## dsPIC33CH512MP508 Family Silicon Errata and Data Sheet Clarification

The dsPIC33CH512MP508 family devices that you have received conform functionally to the current Device Data Sheet (DS70005371D), except for the anomalies described in this document.

**FIGURE 1-1: I/O RAMP**

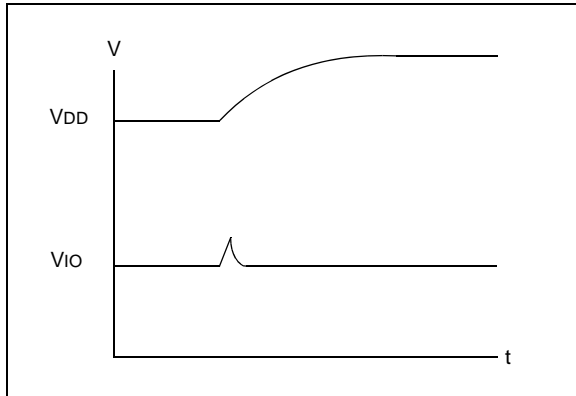
During a fast device power-up, when the VDD ramp is less than 4 mS, the I/O pins may drive up to 100  $\mu$ A current for a duration of up to 10  $\mu$ S (Figure 1-1).

1. Slow down the VDD ramp time (greater than 4 mS for VDD to ramp 0V to 3.3V).
2. Ensure the circuitry that is connected to the pins can endure this pulse.

Example applications affected may include complementary power switches, where a transient current shoot-through might occur. High-voltage applications with complementary switches should power the high-voltage 200  $\mu$ Sec later than powering the dsPIC<sup>®</sup> device to avoid the current shoot-through. This behavior is specific to each device and not affected by aging.
